SERVICE INFORMATION NO. SI 20-054

Rotax Alert Service Bulletin ASB-912-061
ATA-Code: 73-00

Replacement of the pressure side fuel hose at fuel pump part no. 893114 for ROTAX® Engine Type 912 (Series)

ATA System: 73-00-00 Fuel system

Fig. 1
Fuel pump

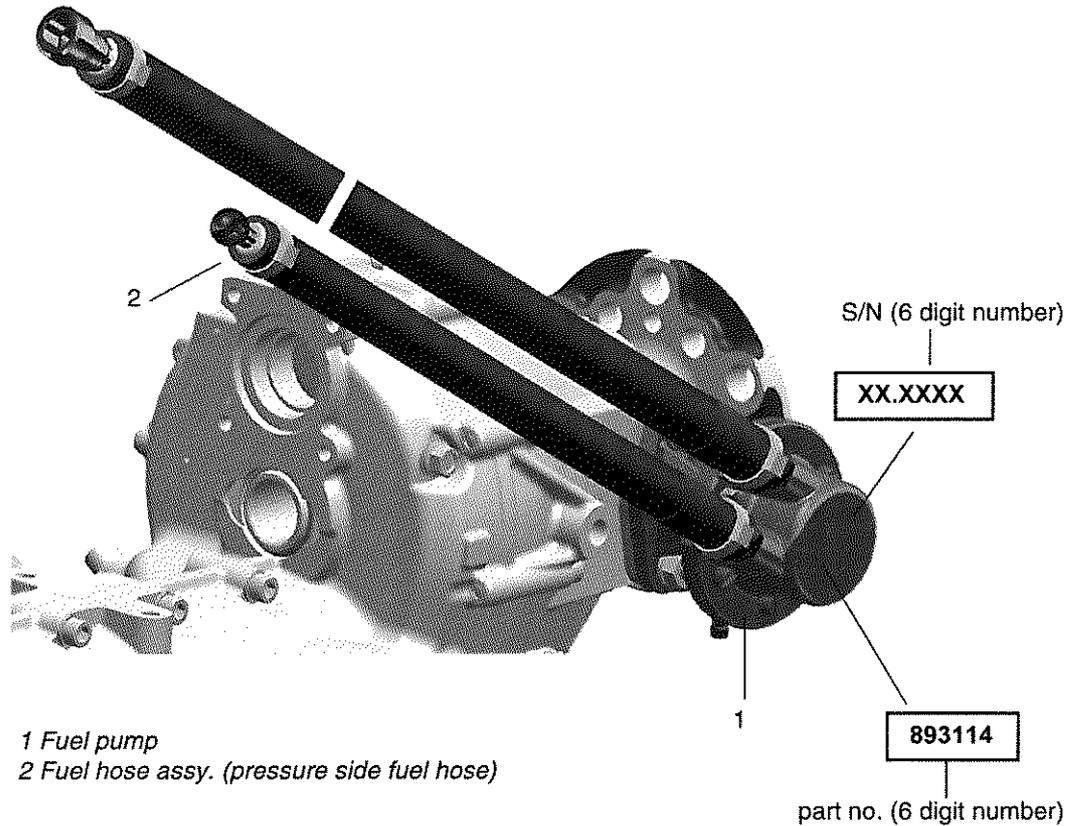
if they are equipped with the genuine ROTAX® fuel pump part no. 893114.
See Fig. 1

Due to variations in the manufacturing of the fuel hose, rubber particles may become detached. These particles can interfere or suppress the fuel mixture in the carburetor. This disturbance in the fuel mixture may lead to rough engine operation, engine misfire and can cause an engine shut down.

1 Fuel pump
2 Fuel hose assy. (pressure side fuel hose)

- **Required before the next flight, the "replacement of the pressure side fuel hose" identified by the engine or fuel pump serial number (S/N) listed in section 1.1) must be conducted according to the following instructions in section 3.**

Accomplishment Intensive work is being carried out to resupply of the verified fuel hoses.
The next steps and appropriate work instructions will be communicated accordingly.

Bild 1
Kraftstoffpumpe

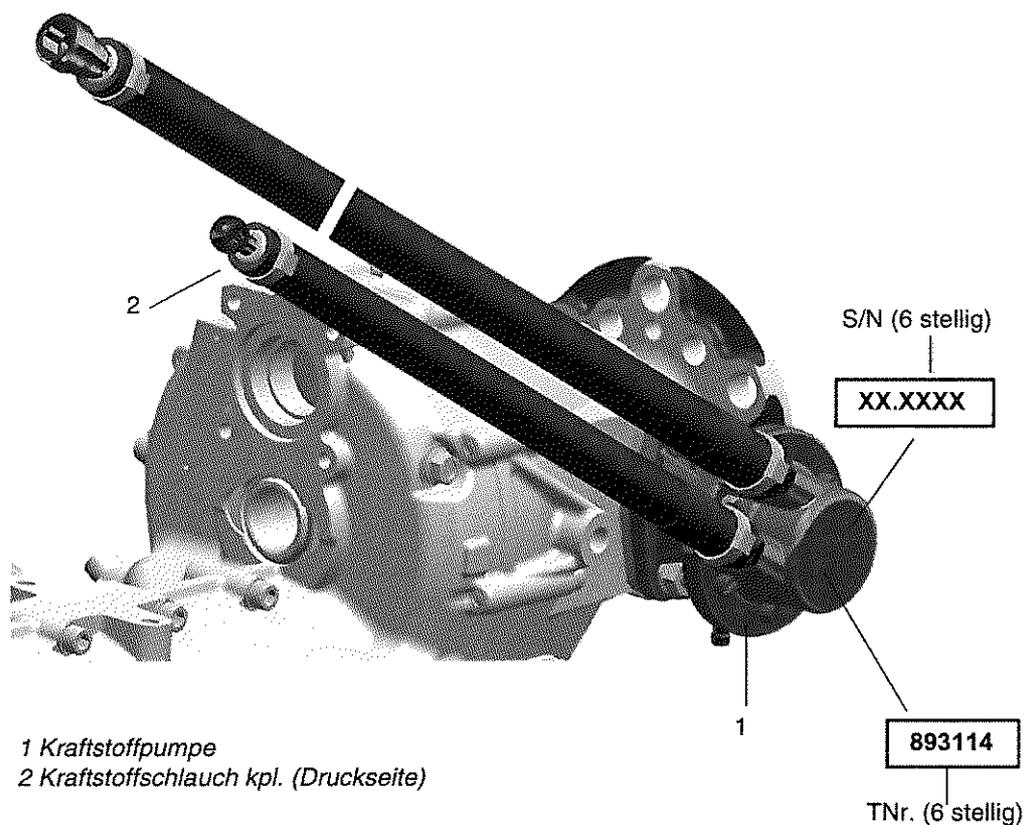
sofern diese mit der ORIGINAL ROTAX® Kraftstoffpumpe TNr. 893114 ausgestattet sind. Siehe dazu Bild 1.

Aufgrund von Abweichungen im Herstellprozess des betroffenen Kraftstoffschlauchs, kann es zu Ablösungen von Gummipartikeln kommen. Diese Partikel können die Gemischaufbereitung im Vergaser behindern bzw. unterbinden. Diese Störung in der Gemischbildung führt unter Umständen zu rauen Motorlauf, Motoraussetzer und eventuell zum Motorstillstand.

- **Vor dem nächsten Flug, ist ein „Austausch des druckseitigen Kraftstoffschlauches“, der unter Betreff 1.1 angeführten Motoren bzw. Kraftstoffpumpen, gemäß machstehender Arbeitsanweisung Kap. 3 durchzuführen.**

Durchführung An der Wiederbeschaffung von den verifizierten Kraftstoffschläuchen wird mit Hochdruck gearbeitet. Die weitere Vorgangsweise und zutreffende Arbeitsanweisung wird entsprechend kommuniziert.
